HIROSE ELECTRIC CO., LTD.

Notice of a Partial Change in Shape to HR10 and HR12 Crimp Terminals

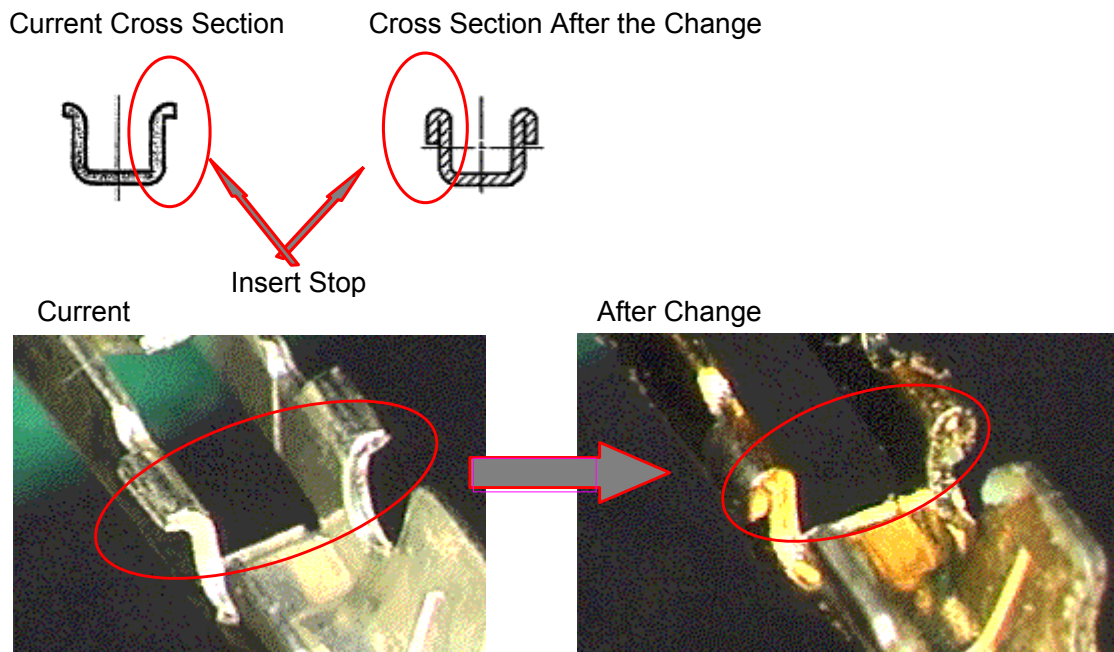
The thickness of the terminal insert stop section will be enlarged to improve ease of assembly and increase the terminal stop strength.

The shape of the contact stop will be changed.

There are no differences in electric performance, mechanical performance, quality or compatibility.
